SoCalGas-70

Blade Energy Partners' Response to SED Data Request-58

Response to SED Data Request-58

Blade response to the CPUC Data Request SED 58 related to Vertilog technology and the casing failure in SS-25 from Reply Testimony of Mr. Robert Carnahan on behalf of SoCalGas.

Figure 2: F-4 1988 Vertilog (Left) and 2016 USIT (Right) Comparison

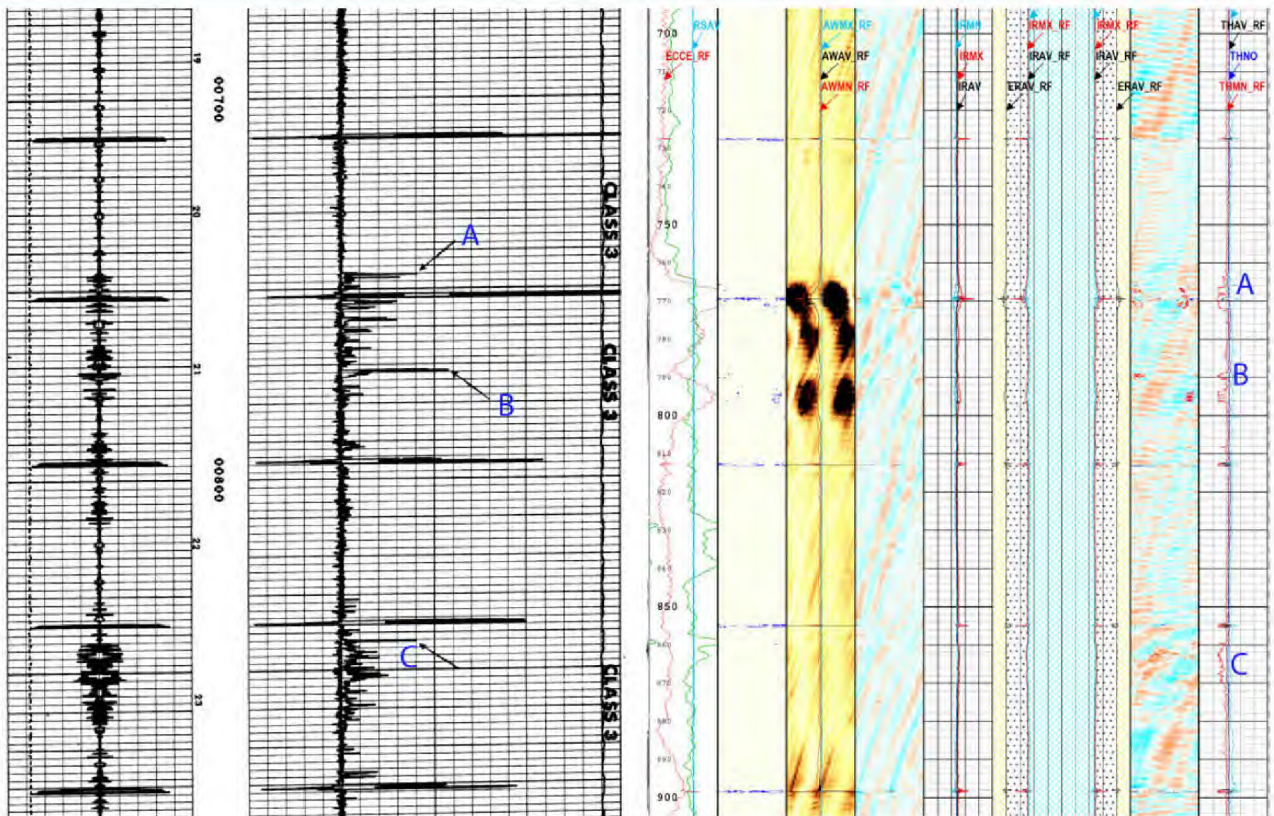
Blade performed an analysis of F-4's 1988 Vertilog as part of the RCA [11] comparing it to the 2016 Ultrasonic Imager (USIT) log. Figure 2 shows these two logs with the Vertilog on the left and USIT on the right. To aid in interpretation from joint to joint, the logs have been adjusted so that the casing connections of each log are aligned. External metal loss is denoted by blue text at A, B, and C on the Vertilog's Flux Leak track, and by the same letter on the USIT's wall thickness track. At A-A, external metal loss is found just above a connection. At B-B, external metal loss is found approximately midway in the joint. At C-C, there is external metal loss below a connection. The point here is the two logs found the same defects.

There was good agreement between the logs at most depths. However, in some cases, the logs did not agree. It should not be assumed that the 2016 USIT log was the more accurate one. In Blade's experience, MFL tools are better at detecting pitting corrosion. In general, it's a flawed concept to compare one log tool to another and automatically claim one is more accurate than the other. Log data has to be compared to truth data (direct measurements of defects) to assess log performance. In today's era, repeatability and reproducibility of pipeline inspection tools are verified independently in pull-through tests (e.g., Pipeline Research Council International Integrity and Inspection projects). Even today, very little data has been published in testing downhole logging tools in controlled environments. An independent comparison of casing inspection logging tools spanning decades does not exist, however, the Vertilog and other casing inspection tools could have been used as an indicator of an issue.

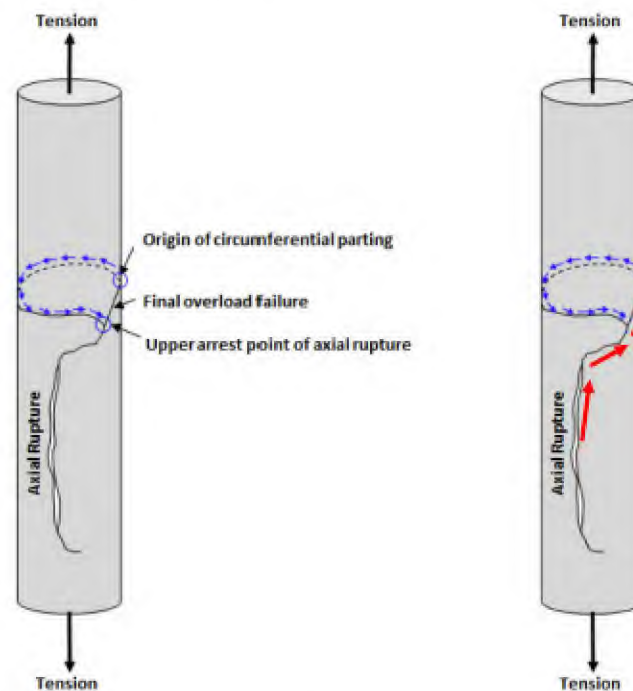
The Blade main report and various supplementary reports assert that the SS-25 7-in. casing's vertical rupture and circumferential parting were two separate events, with the circumferential parting occurring some period of time after the initial vertical rupture, but while the well was still on injection. To the contrary, it is evident the SS-25 7-in. casing vertical rupture and circumferential parting occurred as a single event, as illustrated in Figure 12 and Figure 13, and for the reasons described below:

Mr. Carnahan's statement does not take into consideration all of the facts provided in Blade's Main and supplementary reports. Central to the argument are two facts. First, there are arrest turning points on both ends of the axial rupture. Second, there is no continuity of chevron marks from the axial rupture to the circumferential parting. This is further discussed in detail below.

On page 54 in Section 2.4 of Blade's Main Report [9], it clearly states: "Visual and stereoscopic examination of the circumferential parting showed that the failure was not a continuation of the axial rupture, but rather re-initiated near the corner on one side of the parted casing. The origin site was determined based on chevron marks identified on the fracture surface. Figure 47 is a (a) laser scan and (b) image which identifies the upper arrest point, circumferential parting initiation site, and the final overload failure. Figure 48 is stitched stereo images showing the chevron marks and propagation direction of the circumferential parting. These observations indicate that the axial rupture and circumferential parting were two separate events despite their close proximity, and that they are most likely related to each other. This is discussed in more detail later within this section." Figures 47 and 48 are extracted from the Blade Main Report.

Figure 67: (a) Stereo Image (b) 3D Schematic of Zones (c) Macro Image of Three Zones

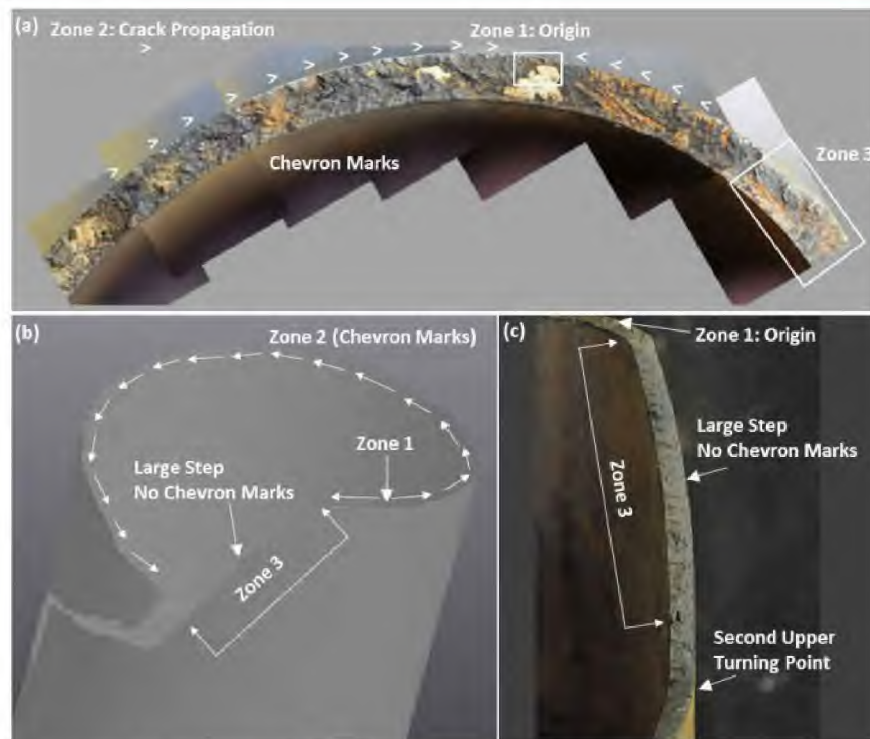
Additional evidence is provided by Blade (Figure 67 on page 71 of Blade's Main report) illustrates the three zones of the circumferential parting. Figure 67 (a) is a stereo image showing the three zones, origin, and the direction of the crack propagation. Figure 67 (b) is a 3D schematic showing the overall circumferential parting steps. Figure 67 (c) is a close-up of the Zone 3 fracture surface, which does not exhibit any chevron marks, thus there is no continuity of the axial fracture.

Based on the factual evidence shown above (pages 72 and 73 in Blade's Main report), Blade concluded "Additional detailed visual and stereoscopic examination showed that the circumferential parting was not an extension of the axial rupture. Chevron marks produced by the circumferential parting did not follow the chevron marks produced by the axial rupture. The initiation site and chevron marks produced by the circumferential parting were located approximately 3.7 in. (94 mm) from the upper arrest point of the axial rupture. Figure 70 (i.e., Figure 12 above quoted by Mr. Carnahan's testimony) is a schematic of the crack path for the axial rupture and circumferential parting. The schematic shows how the circumferential parting initiated above the arrest point of the axial rupture. The crack propagated circumferentially until it reached the axial rupture arrest point. The final ligament failed due to the axial load generated by the weight and tension of the 7 in. casing string. **The axial rupture and circumferential parting are thought to be two separate events because there was no evidence that the chevron marks from the axial rupture continued into the circumferential parting.** The close proximity of the two failures suggests that they are related despite being two separate events." (emphasis added)

Figure 14. Illustration of chevron marks on a steel fracture surface.⁷⁵

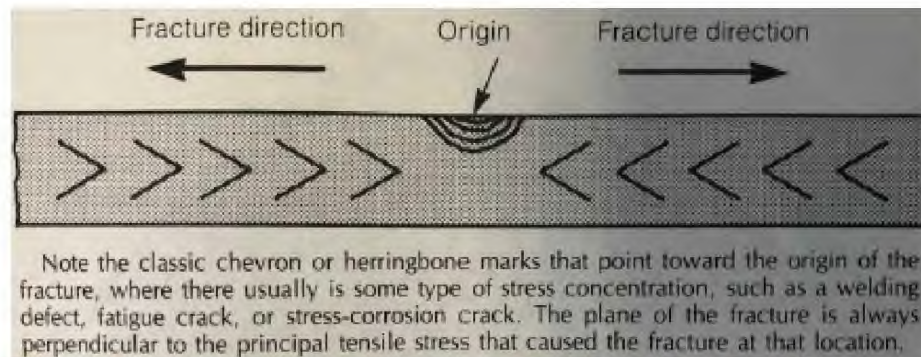
The SS-25 fracture surface exhibits clear chevron marks at a number of locations. Chevron marks denote the direction of propagation of cracks in steels – the apex of the chevron points toward the fracture origin (Figure 14). Chevron marks on the SS-25 fracture surface show clearly that the circumferential fracture is an extension of the axial fracture (Figure 15). This interpretation is consistent with remarkably similar chevron marks shown in a textbook on failure analysis (Figure 16).

Blade disagrees with Mr. Carnahan's testimony because he does not show with metallurgical evidence, the extension of the axial fracture to the circumferential parting. Therefore, there is no metallurgical evidence to support the interpretation that axial rupture and circumferential parting are one event.

Mr. Carnahan's testimony correctly states that "the SS-25 fracture surface exhibits clear chevron marks at a number of locations. Chevron marks denote the direction of propagation of cracks in steels—the apex of the chevron points toward the fracture origin (Figure 14 provided by Mr. Carnahan in his testimony)", however, he incorrectly states that, "chevron marks on the SS-25

fracture surface show clearly that the circumferential fracture is an extension of the axial fracture (Figure 15)". Mr. Carnahan did not show where in the figure that he clearly saw the chevron marks extending from the axial fracture to the circumferential fracture. In contrast, as previously indicated in Blade's response to Mr. Carnahan's Statement 7, Blade provided macro- and micro-fractographic evidence in the Main and Supplementary Reports, see Figure 67 on page 71 of the Main Report, which shows no chevron marks present after the axial fracture was arrested and no chevron marks on the final overload rupture.

Figure 68 (a), Page 72 Blade Main Report

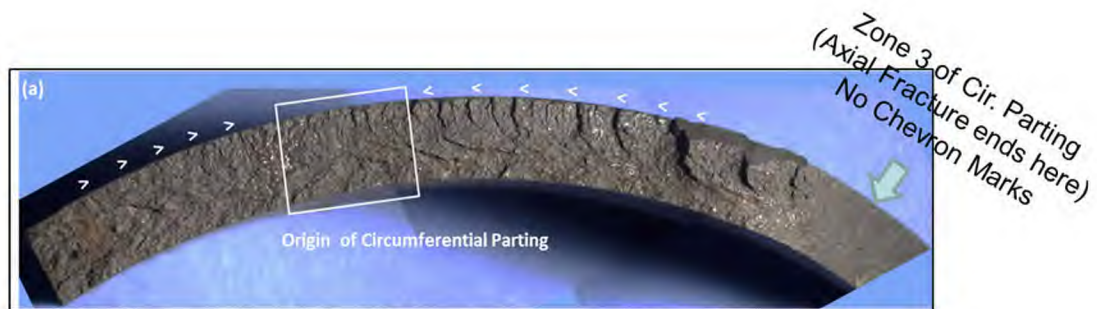
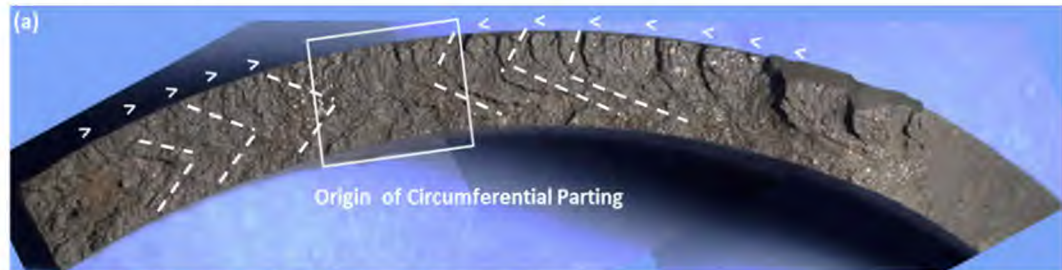
In the caption of Figure 15 below, Mr. Carnahan states "Blade misidentified the chevron marks as flowing towards the origin. Based on both my physical inspection on February 27-28, 2020, and my analysis of the image, the chevron marks travel to the right, as indicated by the red arrows at the bottom of the figure."

Figure 15. Figure 68 from page 72 of Blade main report. Red rectangle encloses backward chevron marks drawn by Blade. Red chevron marks inserted above are consistent with chevron marks present on the fracture surface. Blade misidentifies the chevron marks as flowing towards the origin. Based on both my physical inspection on February 27-28, 2020, and my analysis of this image, the chevron marks travel to the right, as indicated by the red arrows at the bottom of the figure.

The figure below (Figure 68 (a), page 72 of Blade Main Report) shows no chevron marks on the final overload rupture. For clarity, we have annotated the upper corner on the right-hand side of the figure with the green arrow) indicating no chevron marks on the final overload failure of Zone 3 of the circumferential parting. On the circumferential fracture surface there is no extension of the axial fracture chevron marks.

Blade disagrees with the statement because the visual and stereomicroscopic examinations performed by Blade showed that the apexes of the chevron marks are in the opposite directions around the origin. This is further clarified in Figure 68(a), page 72 of the Blade Main Report below that shows the chevron marks point back towards the origin from either side of the origin. For

clarity, white dashed lines have been added to the figure to outline the chevron marks that point back towards the origin from either side of the origin. This is inconsistent with Figure 16 of Mr. Carnahan's testimony.

Figure 17. There are no features in either of the areas shown in Blade Figures 68b or 68c that suggest the existence of a fracture origin.

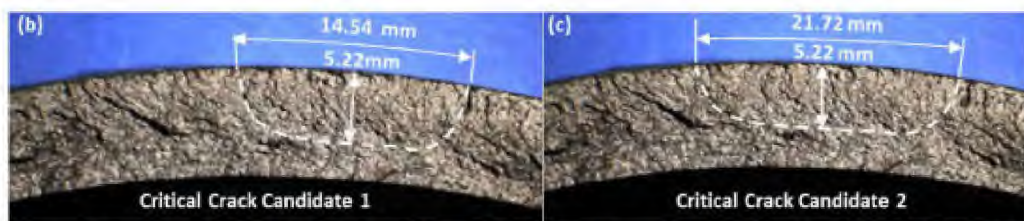
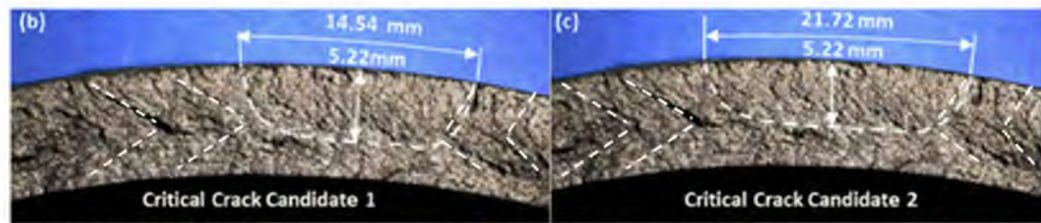
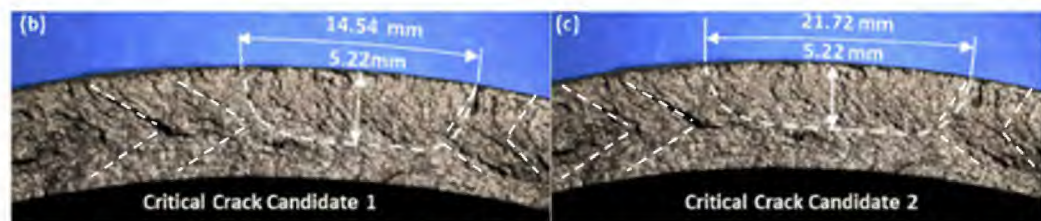
Blade's contention that a separate fracture origin exists on the circumferential portion of the fracture is incorrect (Figure 17). Rather than a fracture origin, this area is merely a continuation of the circumferential portion of the fracture. Fracture surface markings within the hypothesized origin are the same as or similar to those outside of the origin.

An examination of the chevron marks in Figure 17 (i.e., Figure 68 in Blade's Main Report, page 72), showed that the features inside the origin were different from chevron marks outside the origin. The examination identified an area (the origin) that was absent of chevron marks but had chevron marks on either side pointing towards it. For clarity, white dashed lines have been added to outline the chevron marks that point back towards to the origin from either side of the origin. This observation is consistent with the illustration, Figure 14, provided by Mr. Carnahan.

Blade identified the fracture origin of the circumferential parting based on the observed apexes of the chevron marks pointing at the origin, along with the presence of a pre-existing OD oxidized flaw. This was also discussed in Statements 9 and 10. Blade identified two semi elliptical areas as possible critical crack sizes (origin) for the circumferential parting based on thorough examination with the stereo microscope and SEM, one is 14.54 mm long x 5.22 mm deep and the other one 21.72 mm long with the same depth, see pages 71 and 72 of Blade's Main Report and Section 3.3.1 on page 134 of Blade's supplementary report *SS-25 Casing Failure Analysis* for details. Figure 17 provided by Mr. Carnahan in Statement 9 (i.e., Figure 68 in Blade's Main Report, page 72), with added dashed lines to outline the chevron marks), showed that the features inside the origin were different from chevron marks outside the origin. The examination identified an area (the origin) that was absent of chevron marks but had chevron marks on either side pointing at it.

Figure 168: Specimen C023A1A1A (a) Stereo and (b) SEM Images of Zone 1 (Origin) Investigation Areas

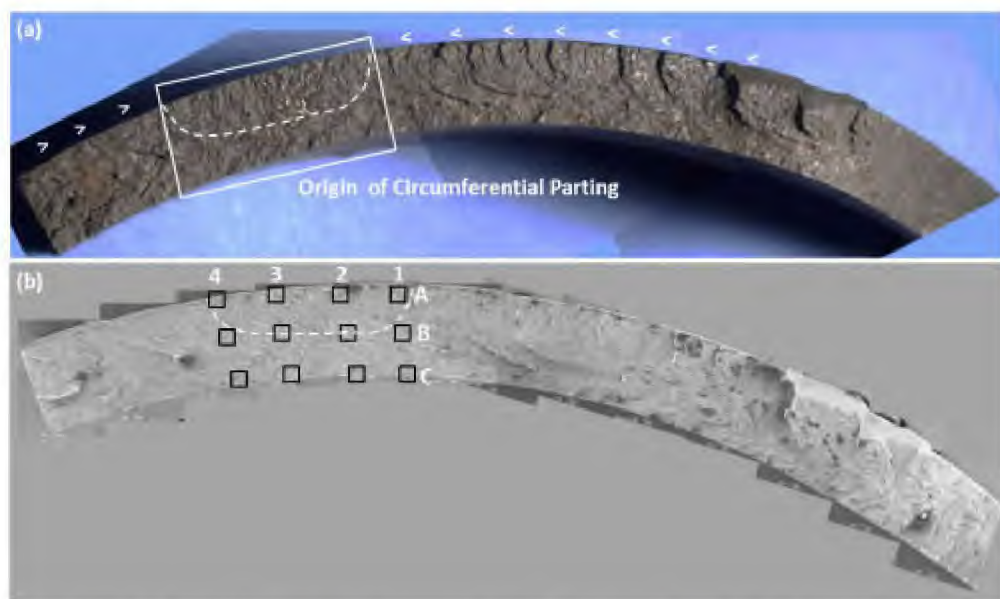
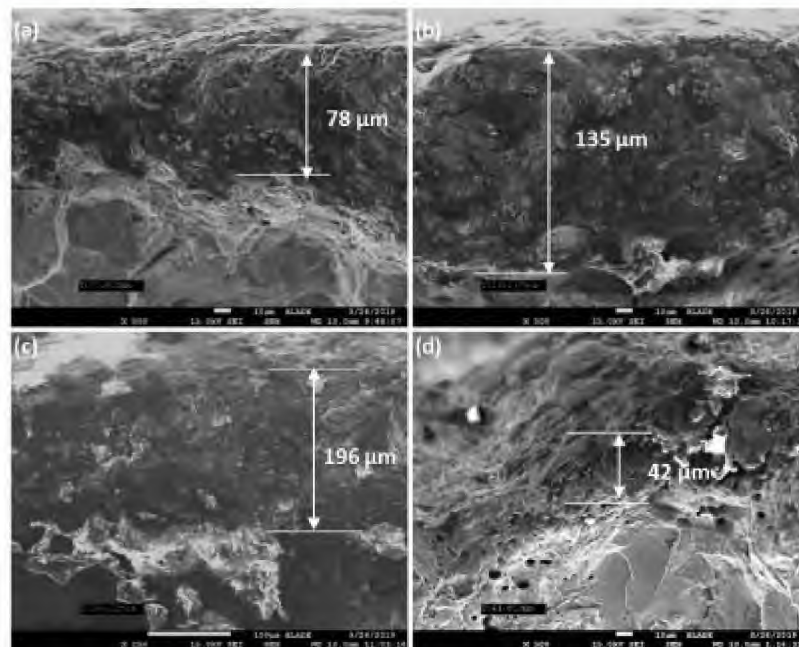
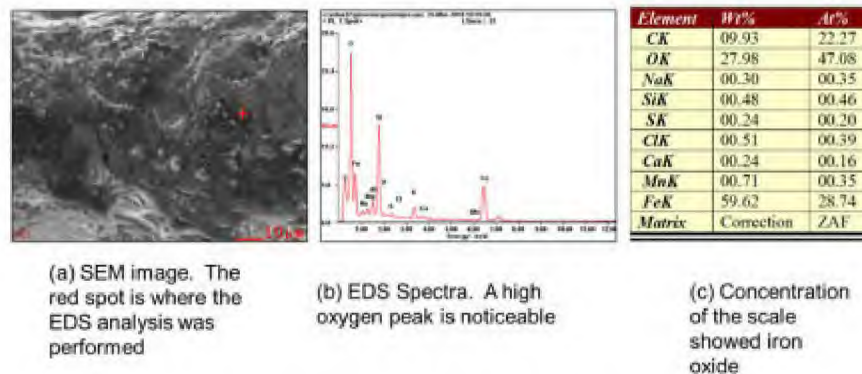
Blade showed that "the SEM examination of Zone 1 identified a pre-existing crack-like flaw on the OD side of the origin", see Figures 168 and 169 on pages 140 – 141 of the *SS-25 Casing Failure Analysis* supplementary report. The crack-like flaw was shallow, with a measured maximum depth of 196 μm . This was a pre-existing flaw and was associated with the origin of the circumferential fracture. Figure 170 in the same supplementary report shows an EDS analysis indicating that the surface of the flaw was severely oxidized by a scale that could not be removed during cleaning. The adjacent fracture surface was easily cleaned and clearly showed cleavage facets. This observation suggests that the flaw existed prior to the circumferential parting. This OD surface flaw may have promoted brittle cracking to form the origin of the circumferential parting, even though the flaw was shallow. The presence of a pre-existing OD oxidized flaw clearly exhibits that the circumferential parting had a separate initiation site. This information was not considered in Mr. Carnahan's testimony.

A complete validation of the size of the origin (i.e., the critical crack size for circumferential parting) is given in Section 2.4.4 of Blade's Main Report (page 74) and in Section 4.3 of the *SS-25 Casing Failure Analysis* supplementary report (page 164). Further discussion on this topic in detail is given in the next section, i.e., Blade's response to Mr. Carnahan testimony Statement 11, Section 2.11 in this document.

Figure 169: SEM Images of Pre-existing Flaws at (a) 1A, (b) 2A, and (d) 4A Taken at 500×, and (c) 3A Taken at 250×

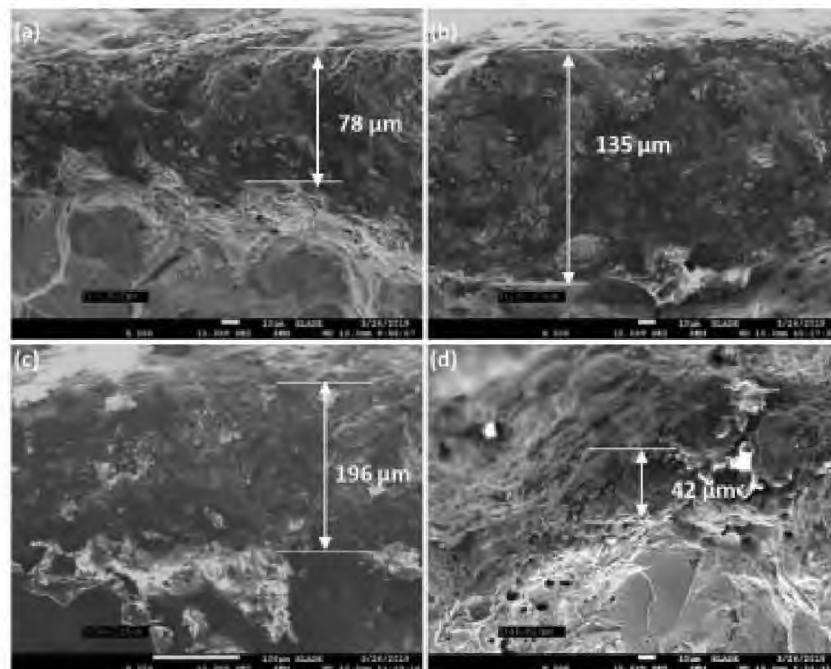
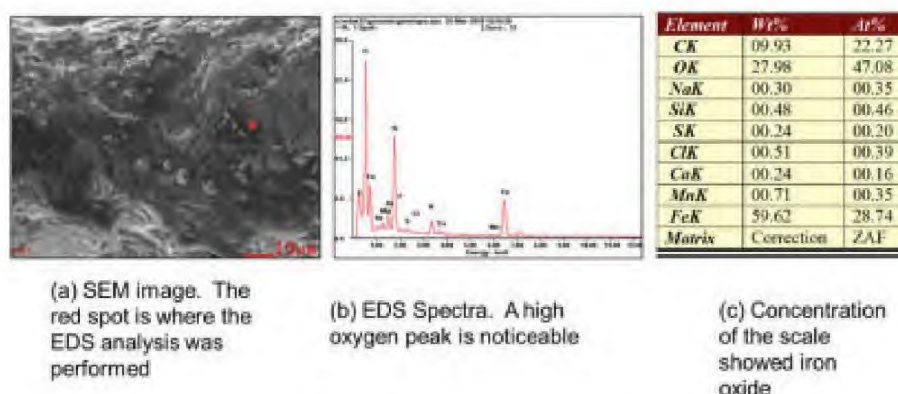
Blade's scanning electron microscope (SEM) photos of the hypothesized origin show predominantly cleavage features.⁷³ Blade reported that no noticeable changes in fracture mode were observed outside of the origin⁷⁴ and their SEM photographs corroborate this. As such, the hypothesized origin must have been created by mechanical force in the same manner as the circumferential parting.

Because the circumferential parting had initiated from a crack-like surface flaw at a temperature below the steel ductile to brittle transition temperature (DBTT), the micro fracture mode would be cleavage. One would not expect any noticeable change in the micro fracture mode outside of the origin that was produced at the same temperature below the ductile to brittle transition temperature of the steel. This was a temperature driven fracture mode. The absence of a ductile origin is consistent with the low temperature experienced, prior to circumferential parting and after the axial rupture, due to escaping gas. As discussed previously, data from all aspects of the failure (metallurgical, loads, temperatures) should be integrated to deliver a precise interpretation. Just interpreting metallurgical data alone is inadequate. A comprehensive interpretation is crucial to identifying the fracture sequence.

The SEM images below show the origin was initiated from a crack like surface flaw by cleavage (Figures 169 and 170 on page 141, *SS-25 Casing Failure Analysis* supplementary report).
